PLAN AND ZONING COMMISSION

Meeting Agenda
Tuesday, September 17, 2024
6:30 PM

2. Kimberley Villas - Updated Building Elevations

Agenda Item: Kimberley Villas – Updated Building Elevations
Report Date: September 12, 2024
Prepared by: Bryan Morrissey *EJC*
Associate Planner

Front Elevation 'A-1' At End Unit Condition - R

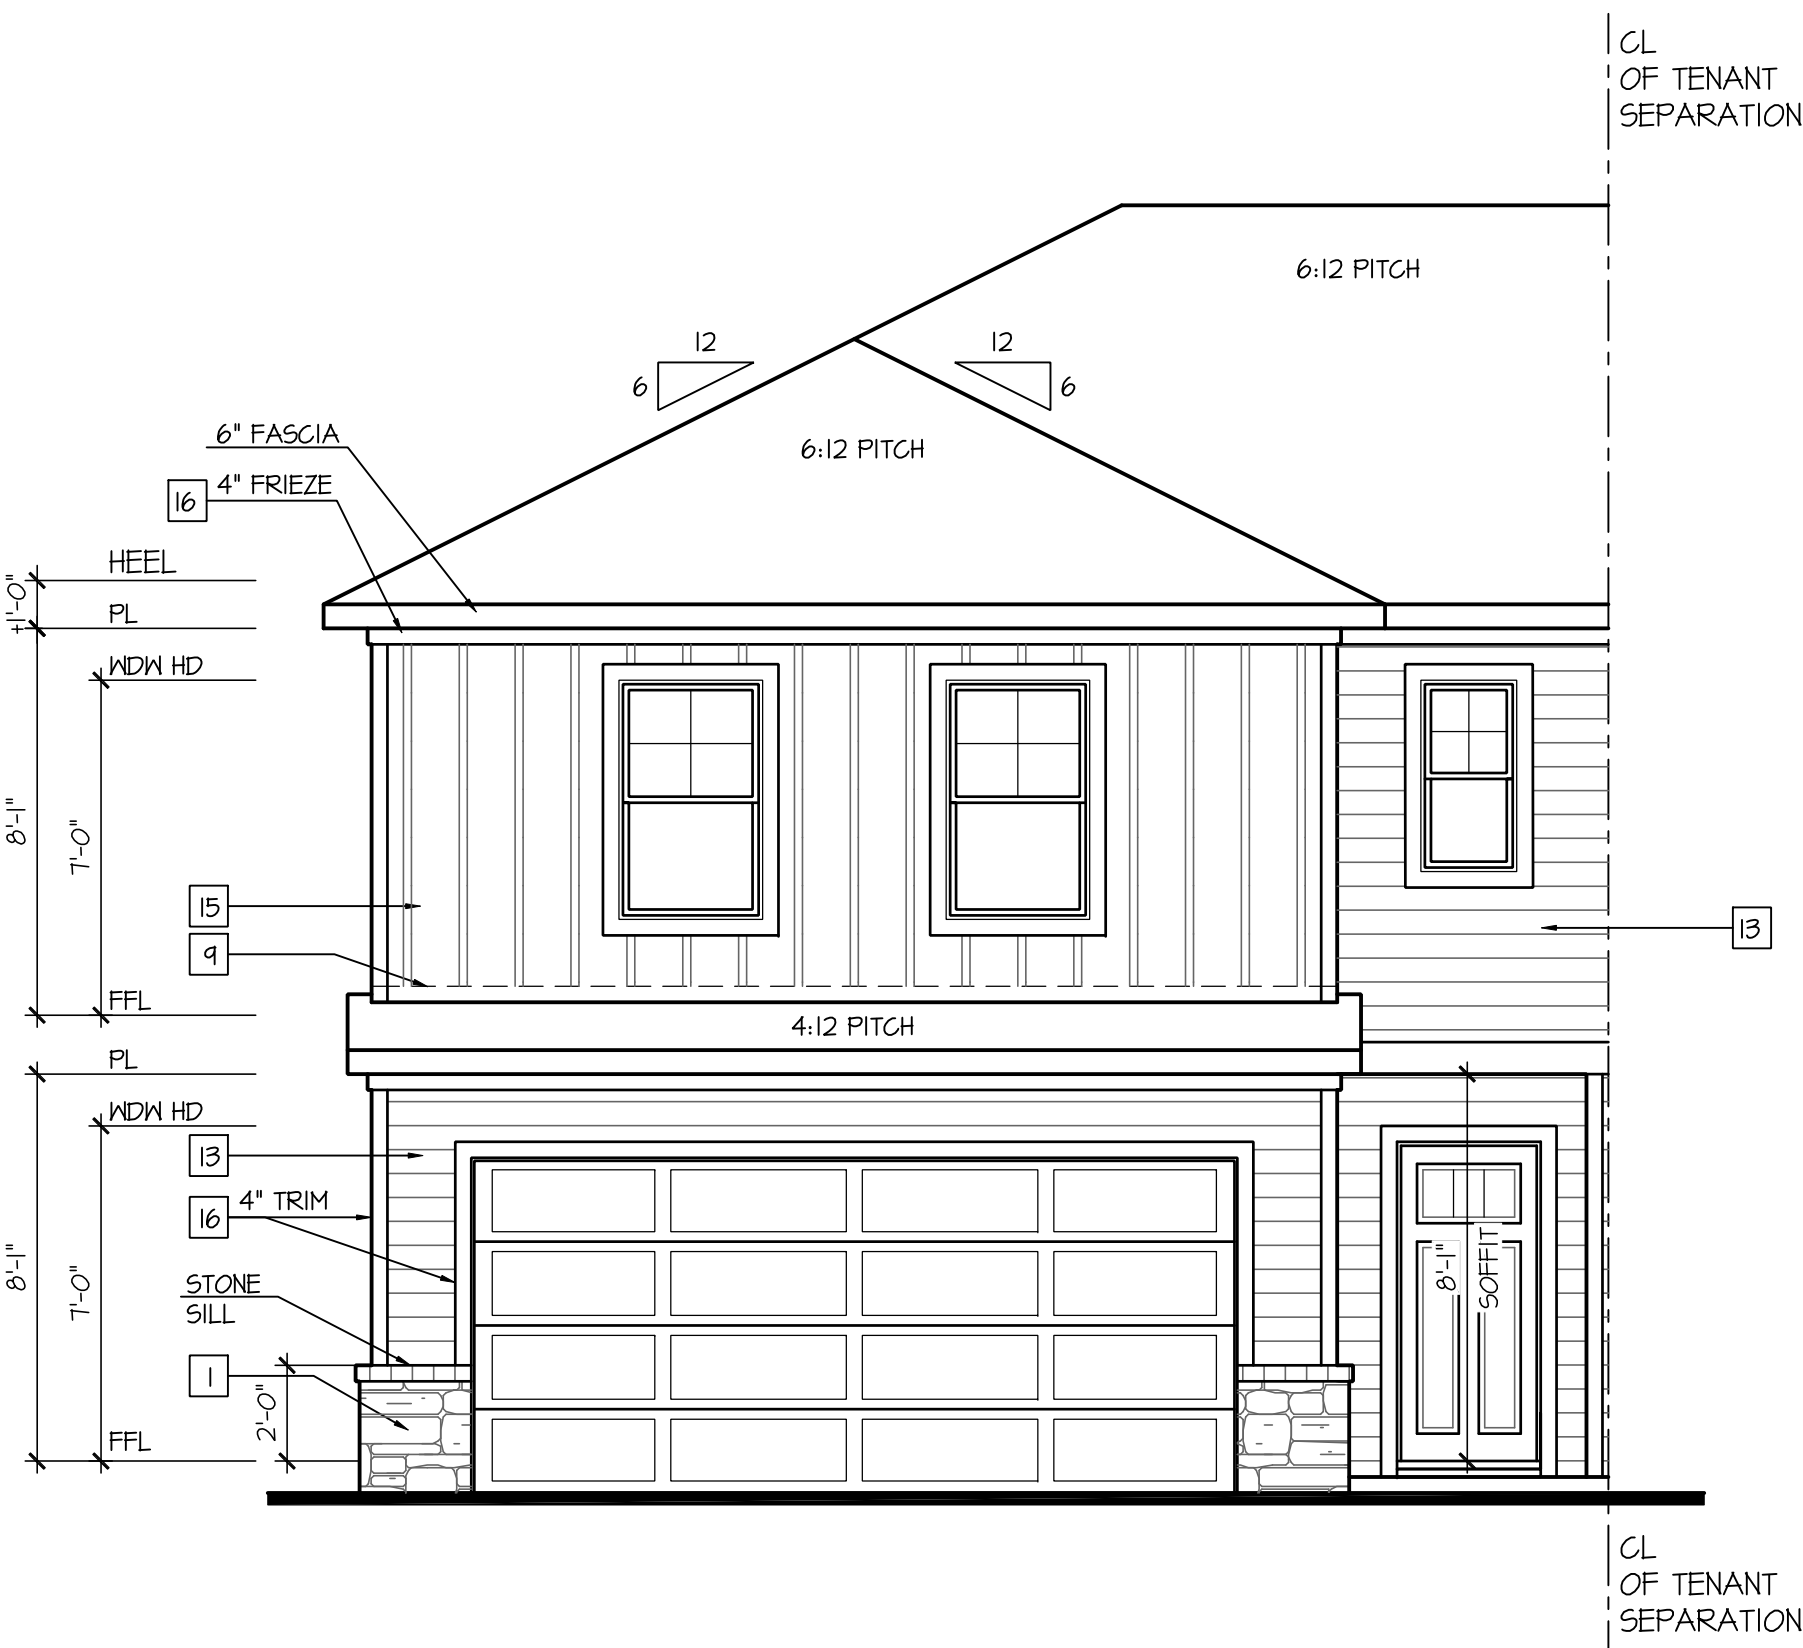
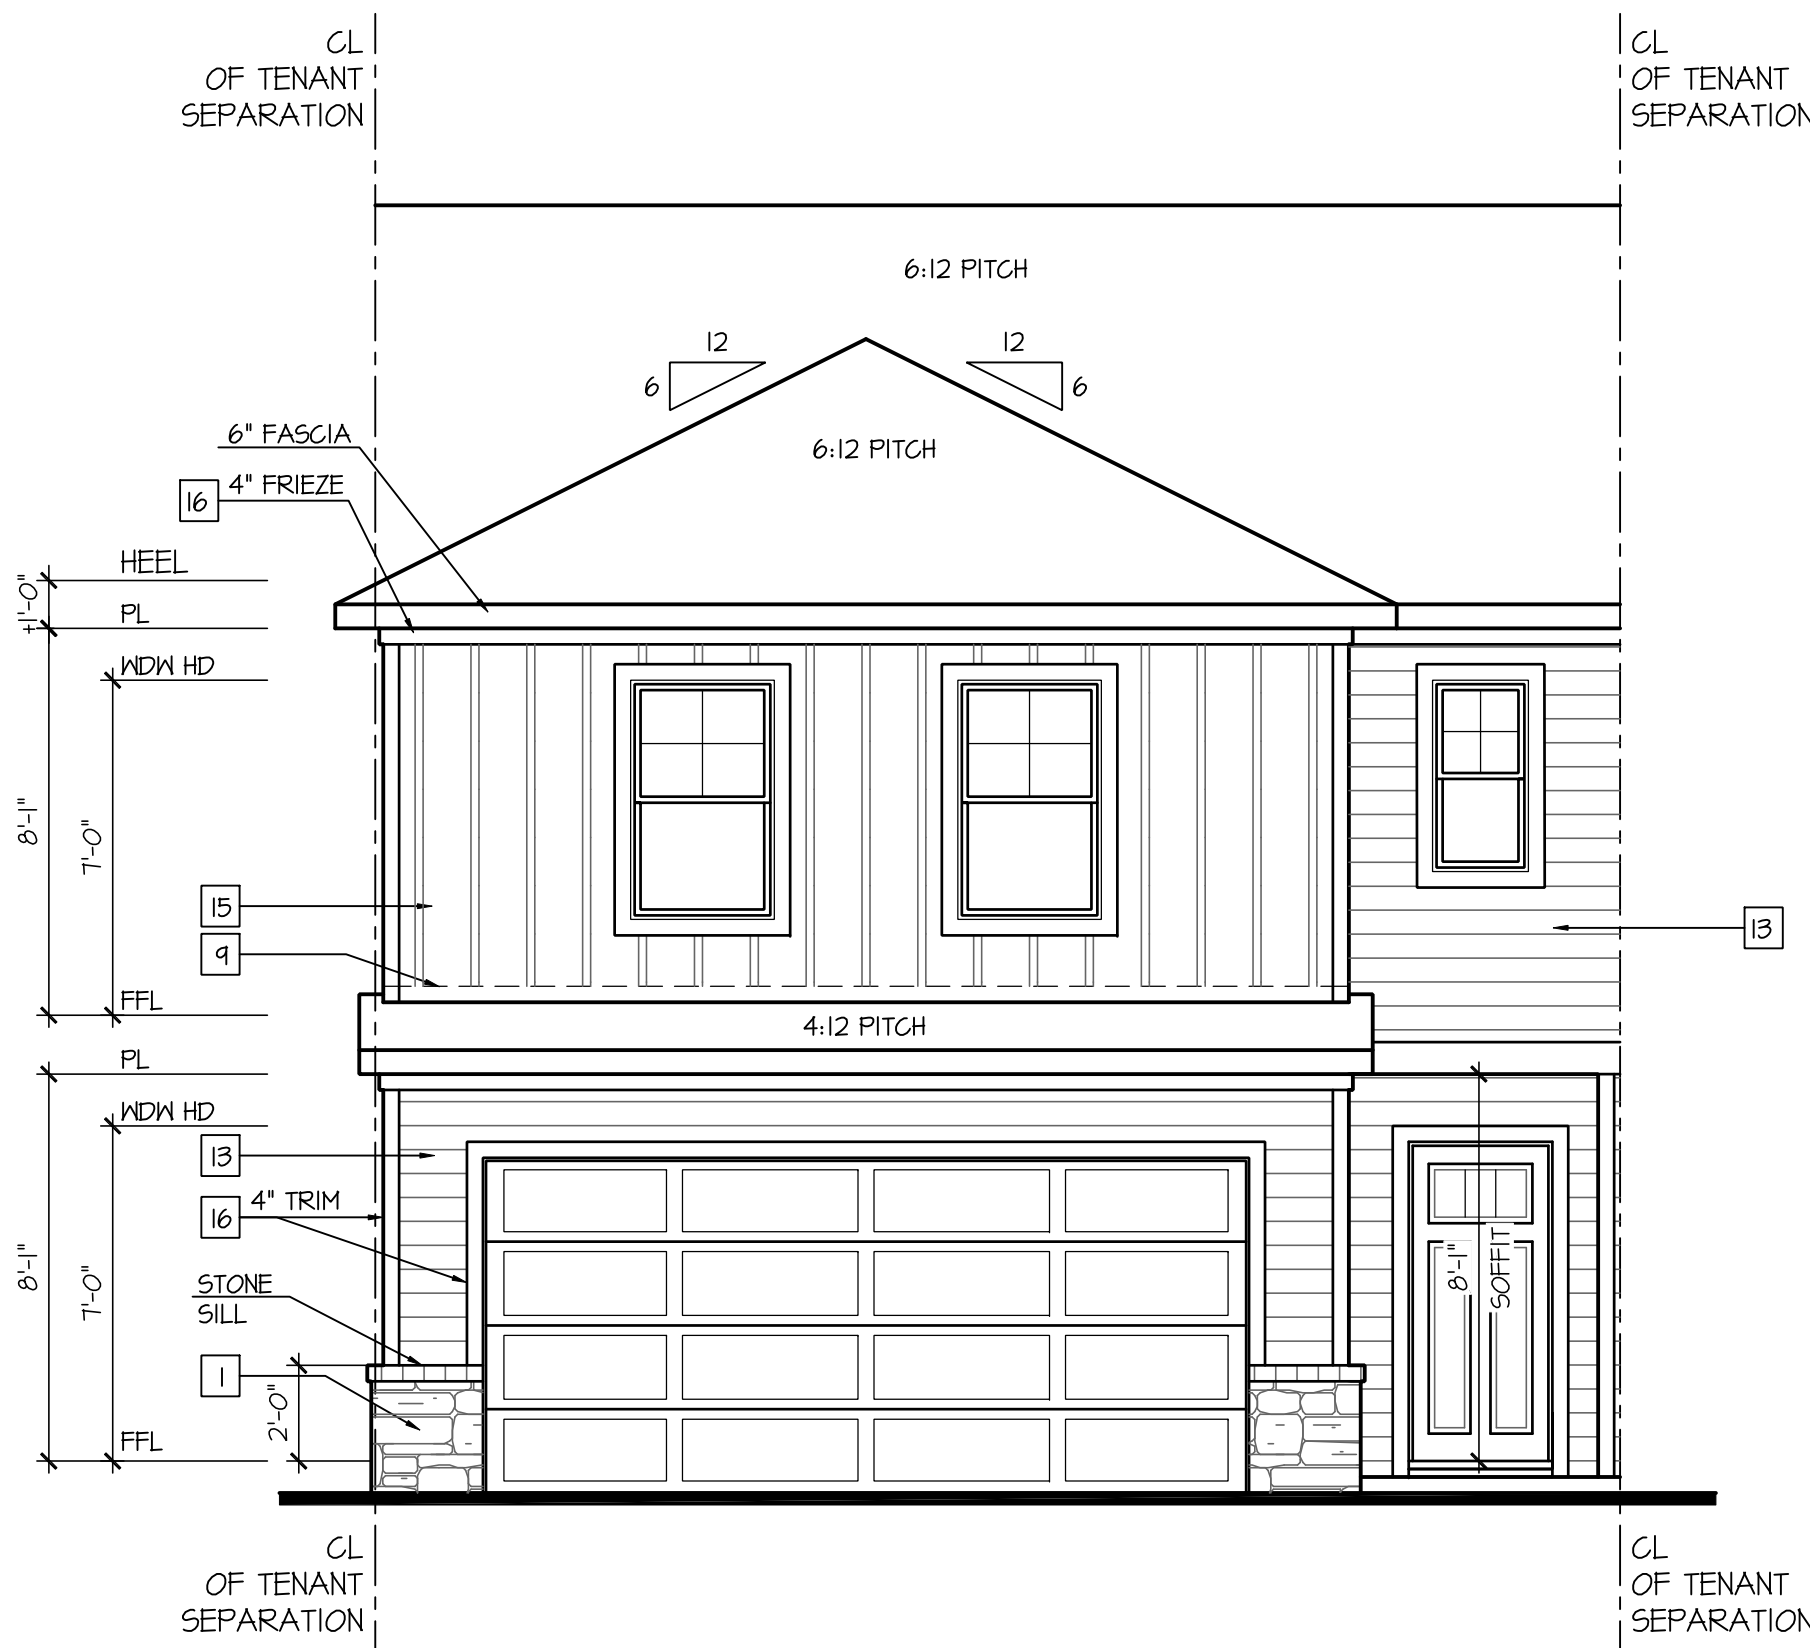
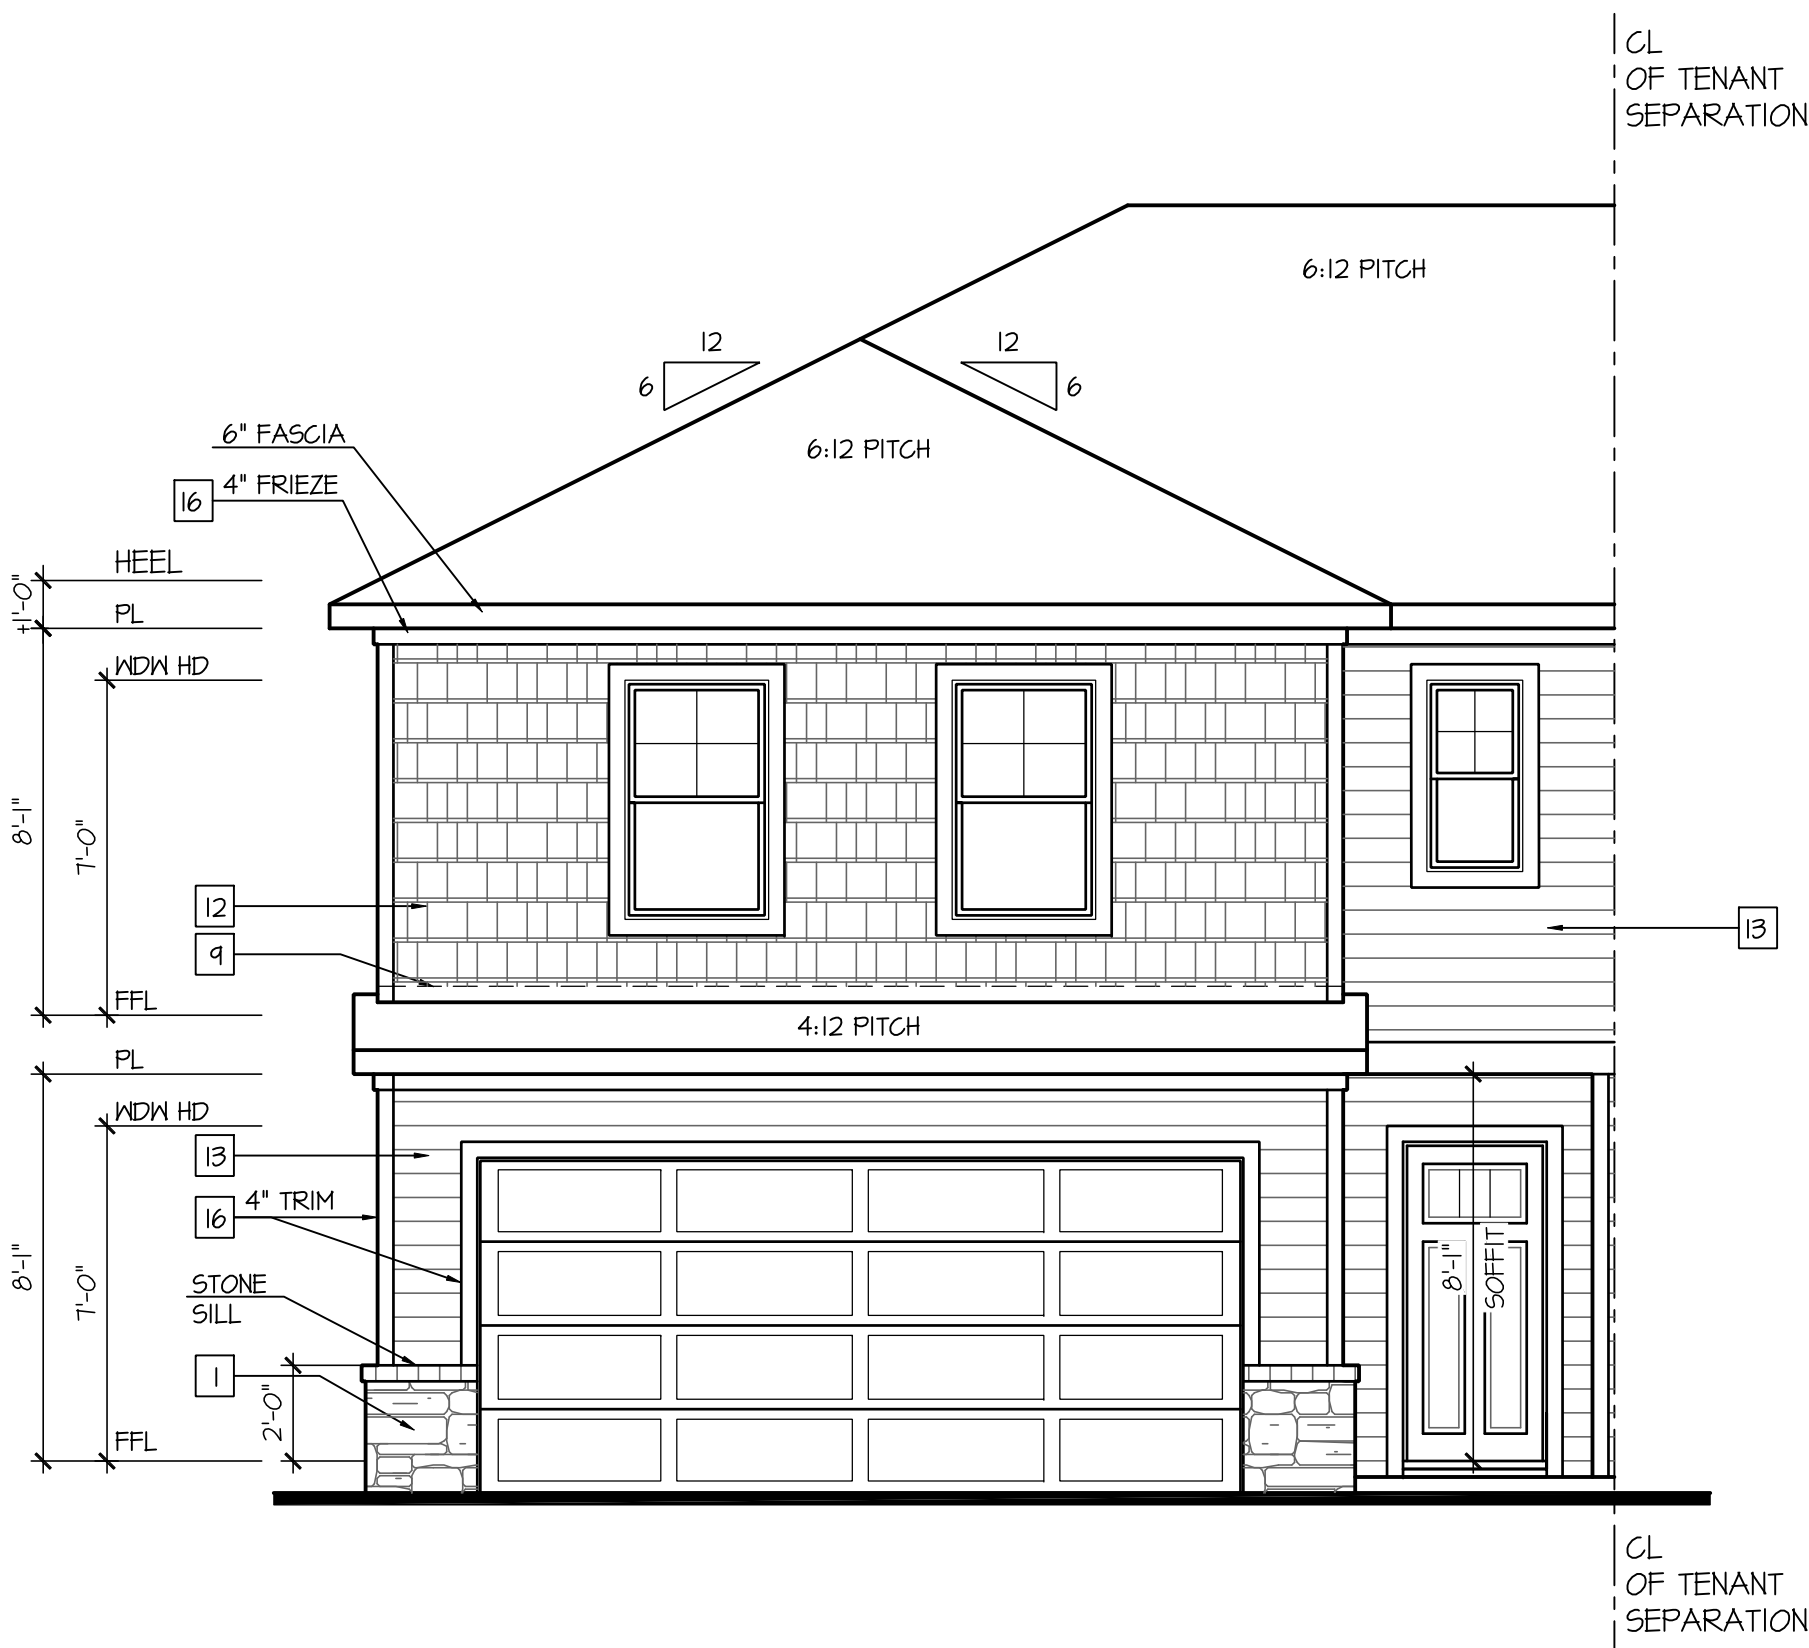
The original building elevations for the townhome units that were approved with the site plan showed substantial amounts of permanent materials (masonry) for units that were visible from the public streets that surrounded the development. The permanent materials were included to ensure that the primary material requirements of the Ankeny City Code were being met. Due to a law that was recently passed by the State of Iowa, material requirements for these kind of townhome developments are no longer enforceable by municipalities.

The updated building elevations that are now being proposed show a significant reduction in the permanent materials that were shown on the original elevations. The majority of the townhome units will be comprised primarily of board and batten and lap siding, with a minimal amount of masonry included on the front of the units. The Sydney elevations will be utilized on Plats 2-4 of Kimberley Villas while the Pattison elevations will be utilized on Plat 1. The color scheme for the overall development will largely be the same to avoid a monotonous and repetitive design.

DR Horton is providing you with new plans for the Kimberley Villa Project in Ankeny Iowa. Changes are as listed:

- We will now do a 2ft stone wrap on the garage front of the unit. Note: XT02 will have stone wrapped on the side of the garage as well
- We do a blend of board and batten and shake on the most front façade/pitch to provide architectural distinction
- We will now do LAP siding down the side and back of the units
